APPLICATION NO.	FILING DATE	FIRST NAMED INVENTOR	ATTORNEY DOCKET NO.	CONFIRMATION NO.
10/812,426	03/30/2004	Tony A. Cutshall	DEP 5069	3354
27777 PHILIP S. JOH	7590 10/18/200° NSON	7	EXAM	IINER
JOHNSON & J	OHNSON	GEORGE, TARA R		
	N & JOHNSON PLAZ VICK, NJ 08933-7003	Α .	ART UNIT	PAPER NUMBER
			3733	
			MAIL DATE	DELIVERY MODE
			10/18/2007	PAPER

DETAILED ACTION

This action is in response to the amendment received on 8/6/2007.

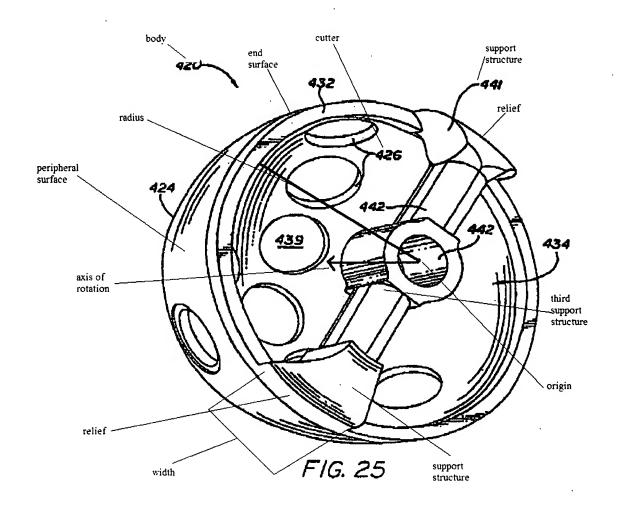
White discloses a reamer comprising a body 420 including a peripheral surface defined by a radius extending from an origin, said body defining an axis of rotation thereof, said body defining an end surface operably connected to peripheral surface and, said body defining a relief surface spaced from the axis of rotation and operably connected to peripheral surface of said body; a cutter 426 operably associated with said body; and a support structure 441 secured to the relief surface of said body (see Figure 25 below and col. 10 lines 63-67 and col. 11 lines1-15). The end surface of said body can be generally planar and perpendicular to the axis of rotation of said body; and the cutter and said body can be integral with each other (see Figure 25 below and col. 10 lines 63-67 and col. 11 lines1-15). The body can also have a general form of a hollow, truncated hemisphere (see Figure 25 below and col. 10 lines 63-67), and the relief

surface of said body can also be generally planar and parallel to the axis of rotation (see Figure 25 below). The body can also define a second relief surface spaced from the first mentioned relief surface (see Figure 25 below) wherein the second relief surface can define a width dimension therebetween, the width dimension being substantially smaller that twice the radius of said body (see Figure 25 below). The reamer can also further comprise second and third support structures secured to the second relief surface and secured to both first and second support structures for interconnecting said support structures, respectively. The reamer can also further comprise a driver (see col. 11 lines 7-15). The support structure can also be integral with said body (see col. 1 lines 13-15), and can also comprise one of a rib, a gusset, a bar, a tube, and a plate (see Figure 25 below and col. 11 lines 13-15). The support structure extends substantially along the relief surface of said body (see Figure 25 below). White further discloses a method comprising providing a cutting tool as disclosed above, cutting an incision in the patient, using the cutting tool to prepare a cavity for the prosthesis; and implanting the prosthesis (see col. 1 lines 20-32, col. 2 lines 44-51 and col. col. 6 lines 10-20).

With respect to claims 1,18,30 and 36, the applicant states that White does not disclose that the relief surface of White does not define "an edge of the" peripheral surface of the body. The examiner respectfully disagrees and would like to point out that as defined by www.dictionary.com, an edge is "a line at which two surfaces of a solid object meet" and believes that the relief of White does in fact define an edge of the peripheral surface. The rejection of claims 1-36 is maintained.
